**Response to NRC's Questions
for
Topical Report MUAP-07001-P(R1)
THE ADVANCED ACCUMULATOR**

Non-Proprietary Version

July 2007

Introduction

Figure 17-1 Measuring system of the Full Height 1/2 Scale Tests

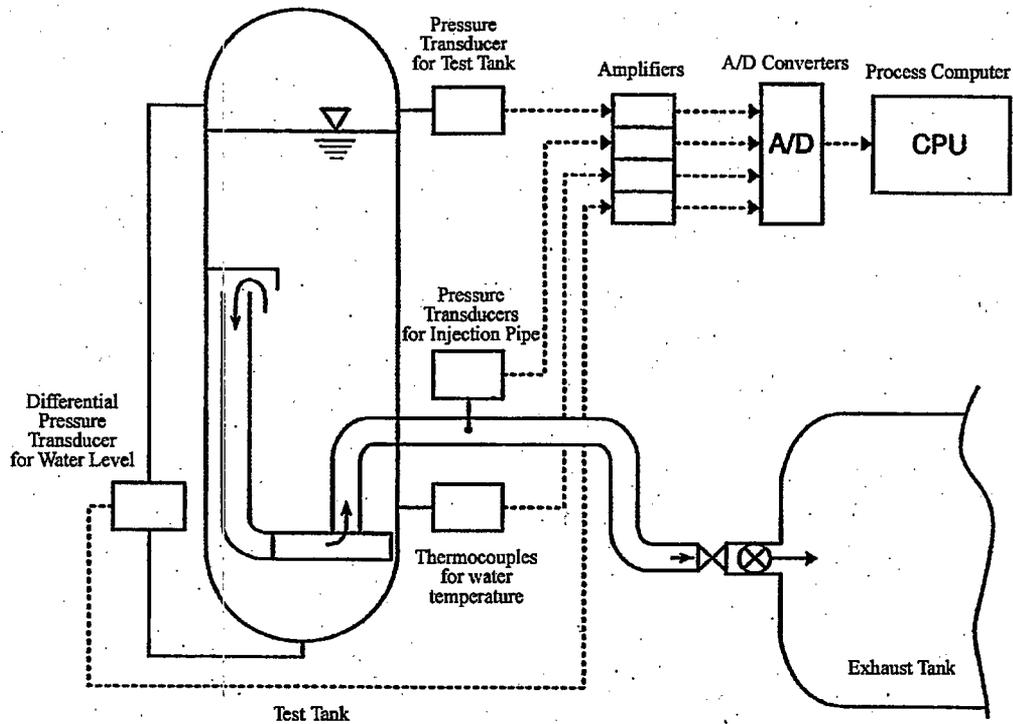
Provide a detailed description of how the instrument errors for each injection stage and each test case are obtained. The description should include (1) the instrument string including, sensor, process rack, analog/digital converter, process computer, and readout devices for each parameter measured in the tests, i.e., temperature, pressure, water level, and flow rate; (2) the accuracy or allowance associated with each instrument component, such as sensor reference, calibration, and measurement accuracies, respectively; rack calibration and measurement accuracies; sensor pressure and temperature effects; rack pressure and temperature effects; drift; process measurement accuracy; instrument range, span, and operating limits, etc.; (3) the methodology for combining the uncertainties, allowances, or errors of the instrument components associated with each parameter to arrive at the overall uncertainty of each measured parameter and (4) the methodology used to arrive at the total uncertainty for the flow rate coefficients for the large and small flow rates.

The measuring system is shown in Figure 17-1. The instrument strings for flow rate coefficients and cavitation factors are:

- (1) Gas pressure in the test tank: pressure transducer for the test tank to amplifier to A/D converter to process computer,
- (2) Water level in the test tank: differential pressure transducer for the water level to amplifier to A/D converter to Process Computer,
- (3) Pressure in the injection pipe: pressure transducers for the injection pipe to amplifiers to A/D converter to process computer, and
- (4) Specific weight of water, or water temperature in the test tank: thermocouple to amplifiers to A/D converter to process computer.
